client
HALTON DISTRICT SCHOOL BOARD
2050 GUELPH LINE
BURLINGTON ONTARIO
project
MILTON DISTRICT HIGH SCHOOL RENOVATION/ADDITION
396 WILLIAMS AVE.
MILTON ONTARIO

Project Name: Milton District High School Renovations

Addendum No.: 03

This Addendum forms part of the Contract Documents and amends the original Drawings, issued May 5, 2026, Rev. 5, as noted below.

drawing title
EXISTING CONDITIONS AND REMOVALS PLAN

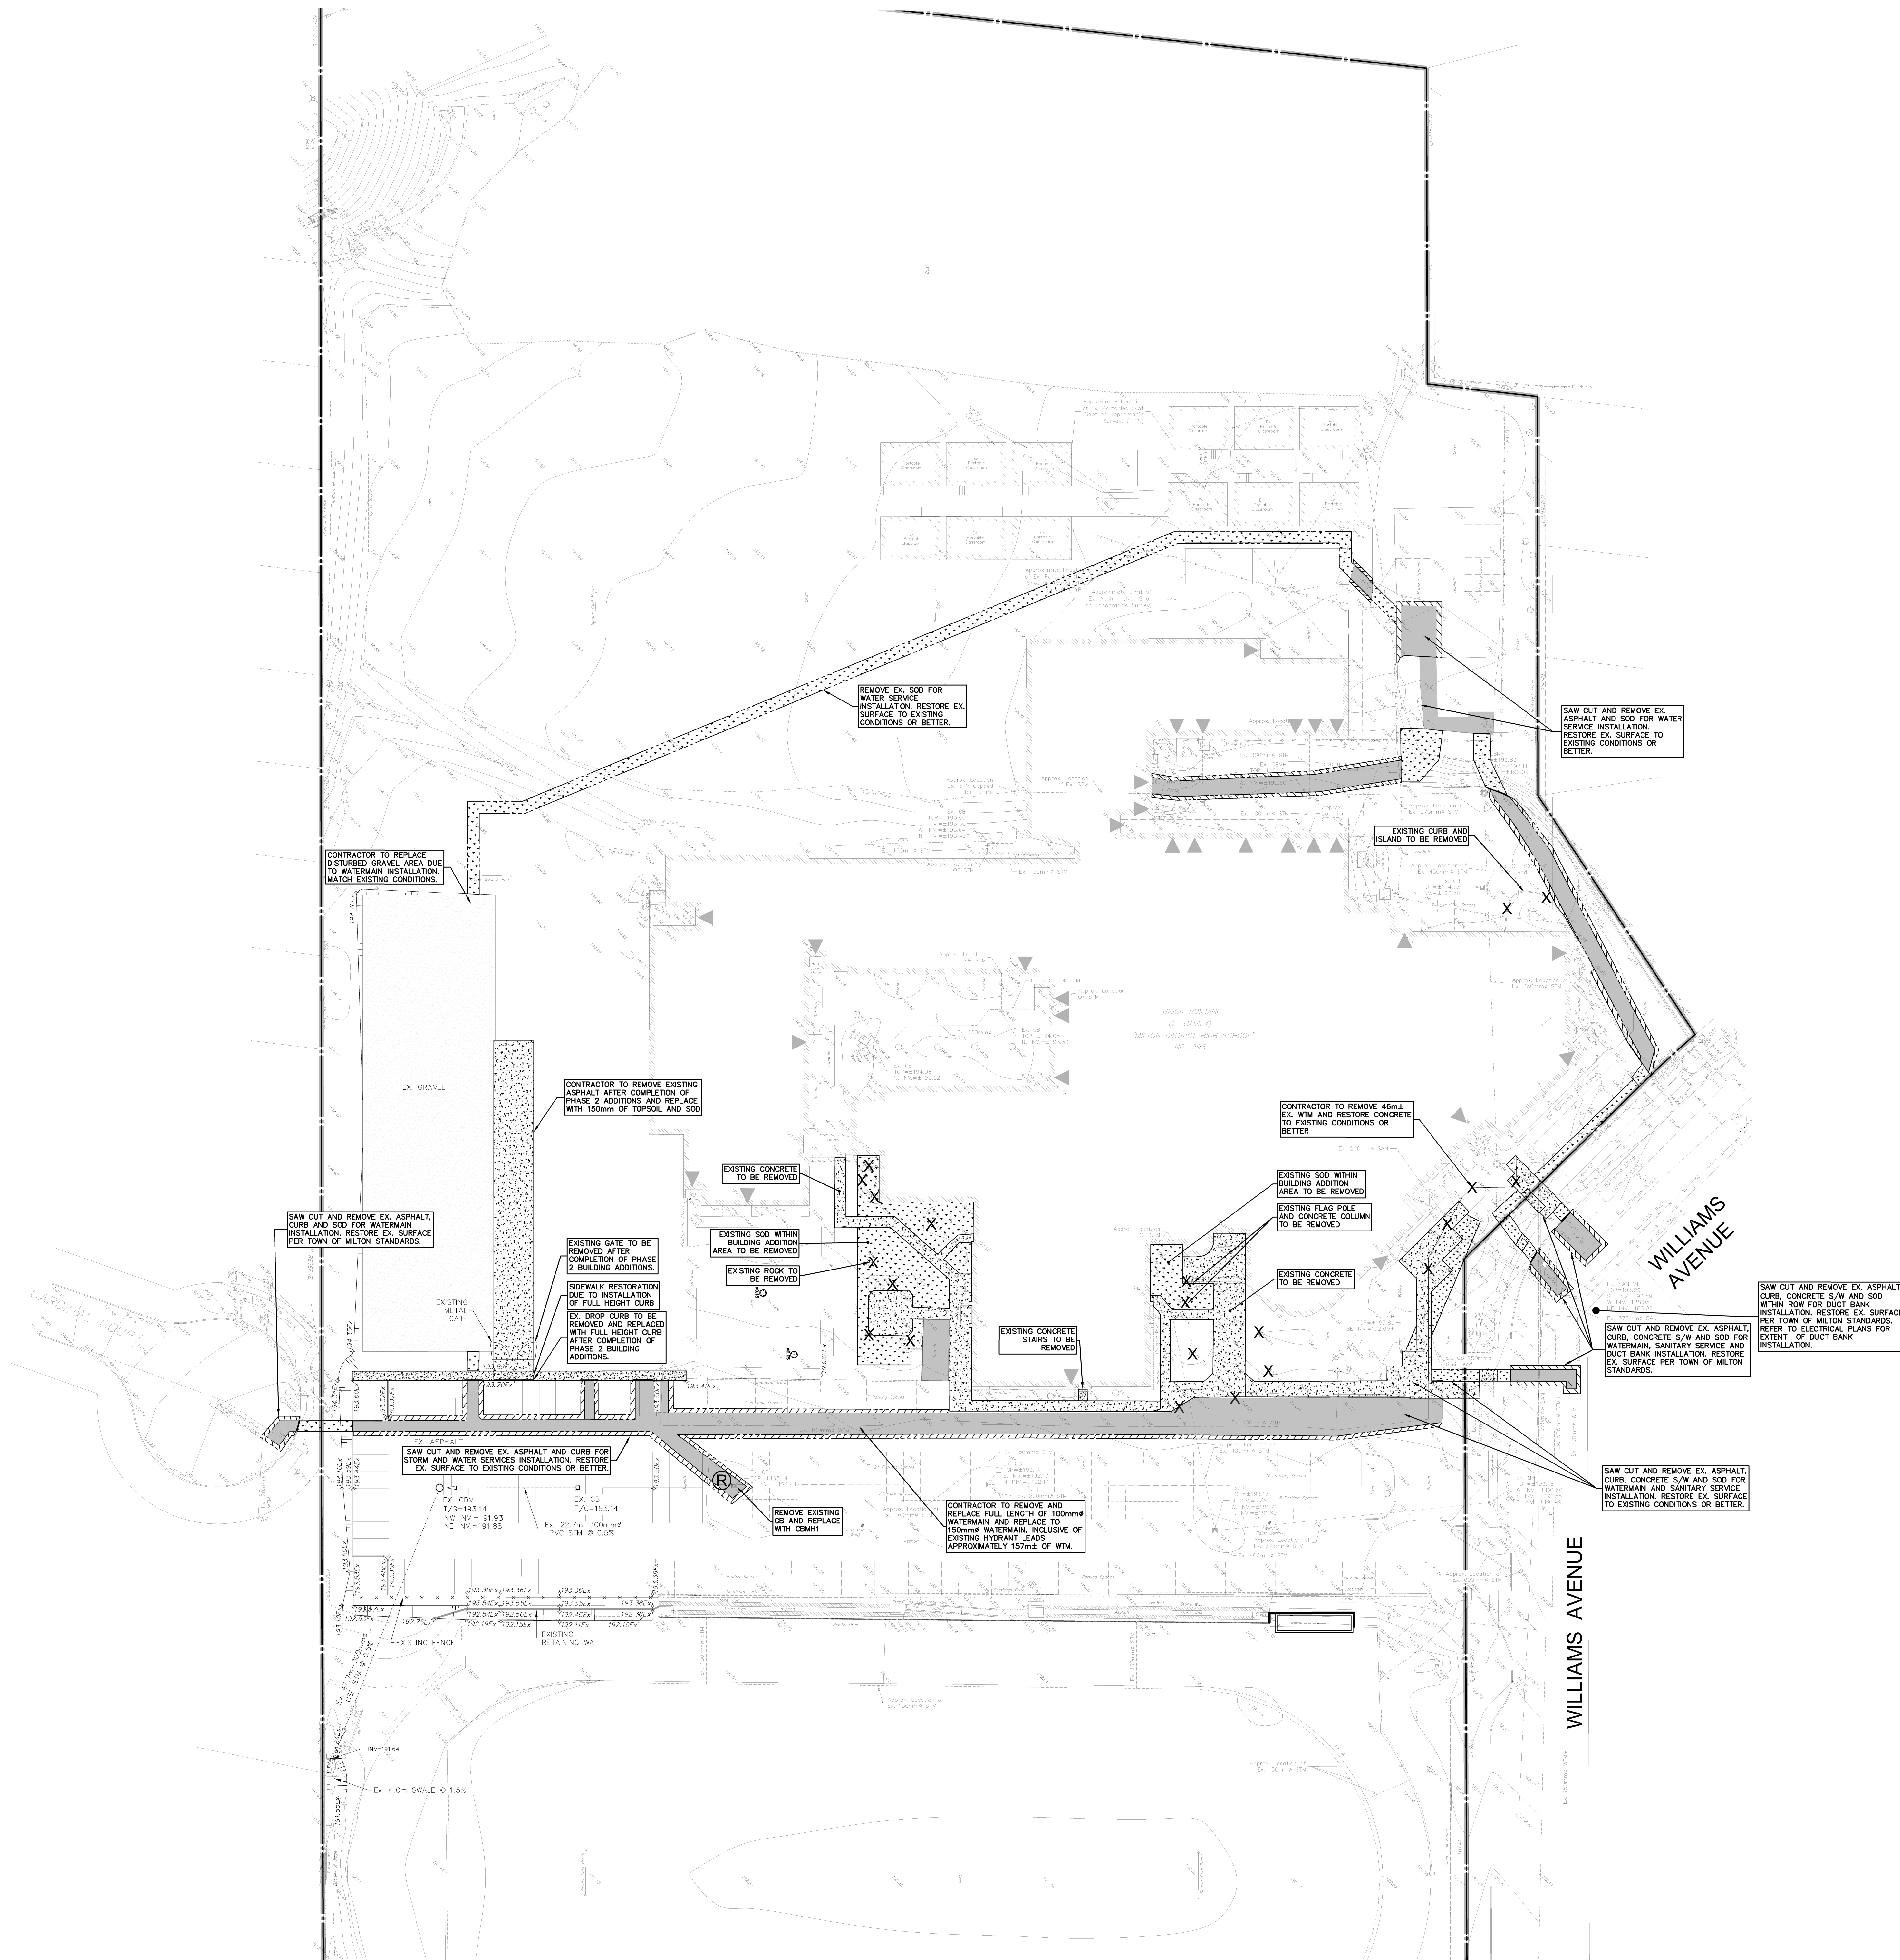
C2.0.(1.)	Existing Conditions and Removals Plan
	<ol style="list-style-type: none"> 1. On-site and right-of-way surface restoration adjusted to align with new electrical duct bank location 2. Watermain removal/replacement quantified. Approximately 46m+/- of 100mm watermain removal. Approximately 157m+/- of watermain replacement from 100mm to 150mm.
C2.1.(1.)	Site Grading and ESC Plan
	<ol style="list-style-type: none"> 1. Addition of 50m of sediment control fence along west property line. 2. On-site and right-of-way surface restoration adjusted to align with new electrical duct bank location
C2.2.(1.)	Site Servicing Plan
	<ol style="list-style-type: none"> 1. On-site and right-of-way surface restoration adjusted to align with new electrical duct bank location 2. New electrical duct bank alignment updated on civil plans. Refer to Electrical Plans for further details regarding the new electrical duct bank.
